# Forth Replacement Crossing

## Public Information Exhibitions: Feedback & Outcomes Report

June 2009

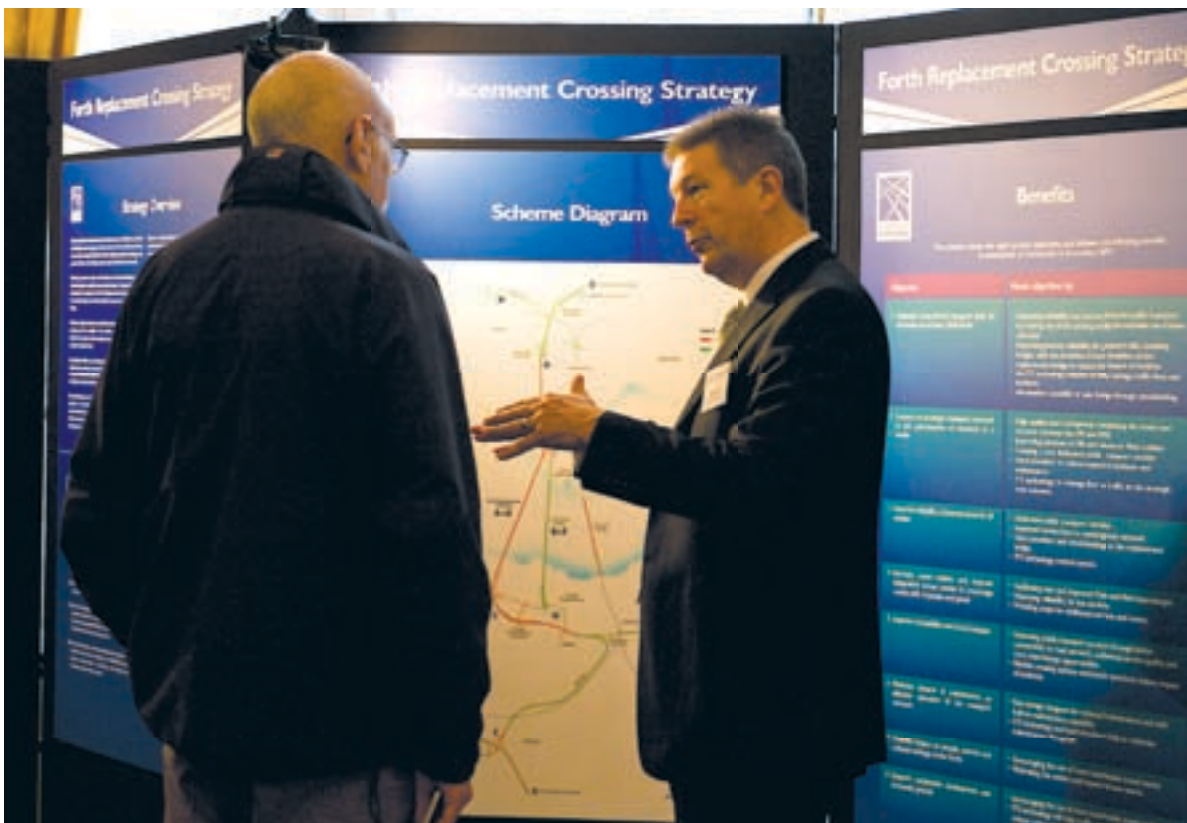
- **Concern regarding the use of Shore Road and Society Road (South Queensferry) during construction**

Transport Scotland does not intend to allow construction access via the main residential areas of Shore Road or Society Road. Restrictions on the use of public roads for access during construction will be included in the Code of Construction Practice, as described above.

Fig 7.3a Indicative junction design South Queensferry, January 2009.

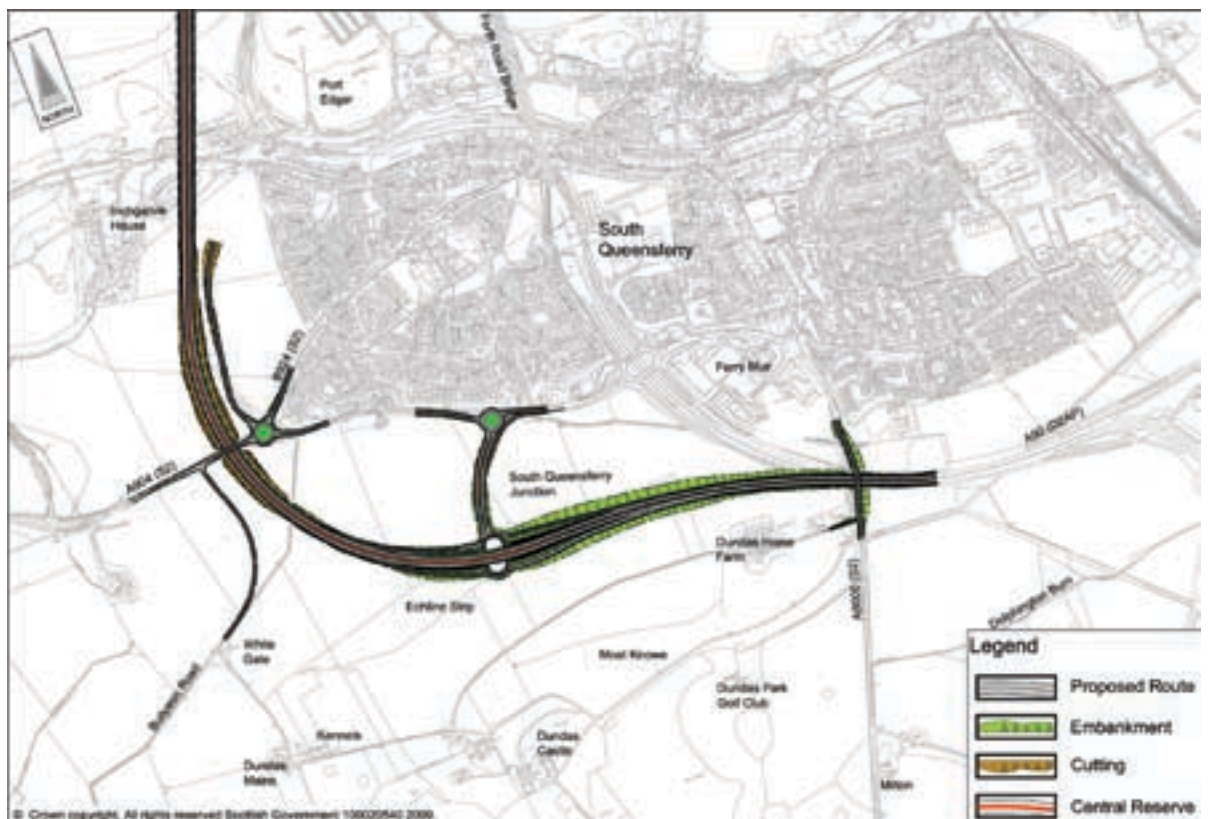
- Concern regarding delay to public transport due to the layout and number of roundabouts at South Queensferry Junction (Repeated Comment RP1)
- Direct access for buses should be provided to/from the A90 at South Queensferry (RP2)
- Direct access for buses and local traffic should be provided from the A90 at South Queensferry (RP8).

At the time of the exhibitions the South Queensferry Junction was located immediately to the south of the A904 Buiyeon Road. The junction was elevated above the main carriageway and a link road was proposed to connect to the A904 Buiyeon Road at a new roundabout.

The strategy for the use of the Forth Road Bridge as a dedicated corridor for public transport, pedestrians and cyclists is unchanged. However new south and northbound slip roads for public transport (buses and taxis) to and from the Forth Road Bridge and A90 have been added to the design at South Queensferry (see Fig 7.3b above). The public transport slip roads are shown in green on the plan.

The slip roads will be dedicated for use by public transport only and will provide more direct connections onto the trunk road network for public transport, effectively extending the dedicated corridor for public transport, pedestrians and cyclists to/from the Forth Road Bridge.

Fig 7.4b Indicative junction Ferrytoll, April 2009.

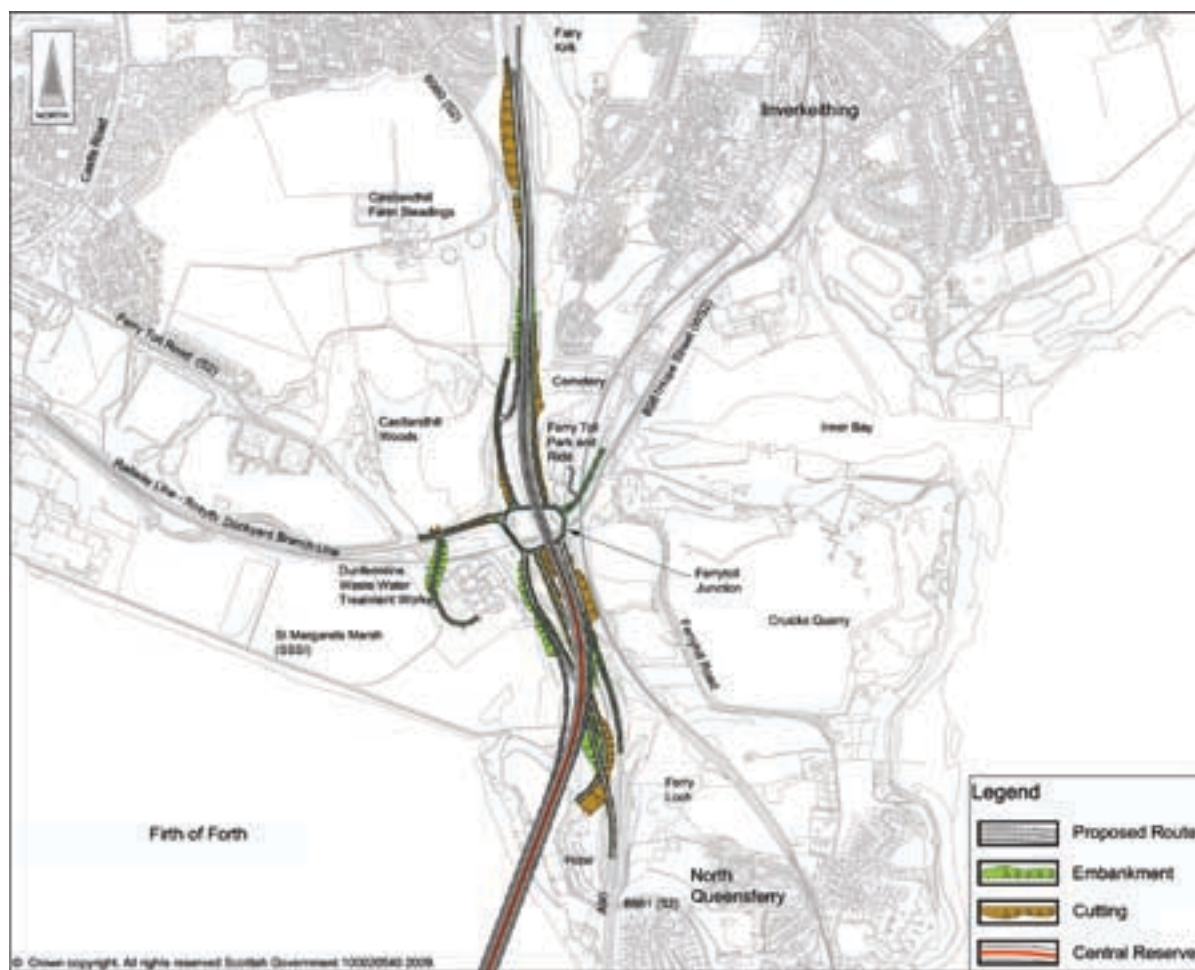
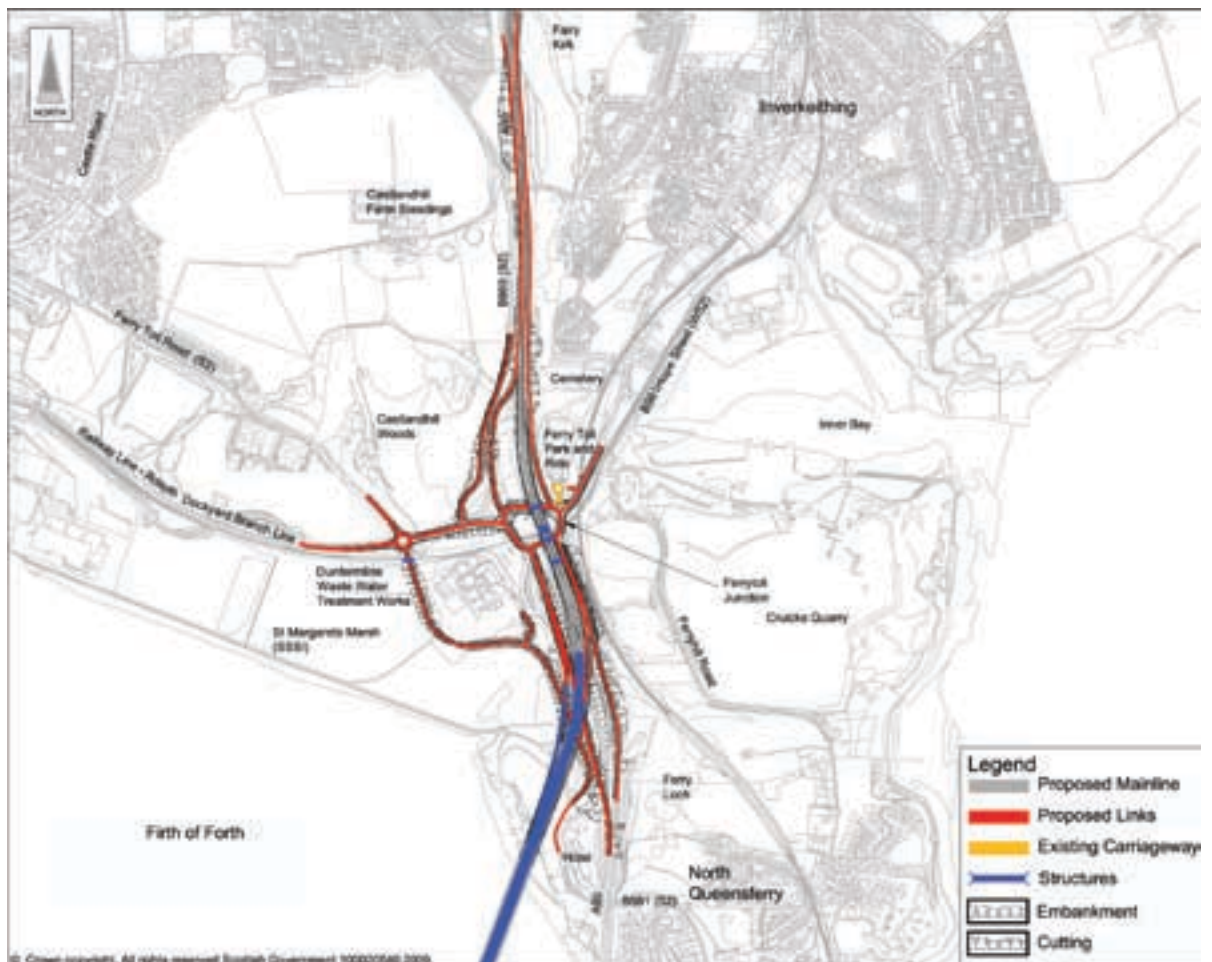
- Junctions on the north side of the Forth are dangerous (Repeated Comment RA3)
- Concern that the junctions appear complicated (RA7)
- Concern regarding local access due to increased traffic flows (RA29)
- Concern regarding traffic disruption during construction (RC3)
- Concern regarding congestion at Ferrytoll during construction (RC5).

- The northbound slip road onto the A90 will lead directly off the new roundabout at Ferrytoll Junction
- The B981 from North Queensferry will pass to the west of the Dunfermline Waste Water Treatment Works to connect to Ferrytoll Road.

The proposed scheme will remove the northbound merge slip road which currently runs onto the A90 from the B980 Castlandhill Road and will replace it with a separate, dedicated slip road which exits directly from the new roundabout at Ferrytoll Junction.

In association with the proposed change above, Castlandhill Road will be realigned and kept separate from the Ferrytoll Junction, joining Ferrytoll Road to the west of the new junction. This will provide local access to and from North Queensferry and Rosyth.

These changes will provide more reliable, simpler and safer access for local traffic travelling to and from North Queensferry, both during and after construction of the crossing.
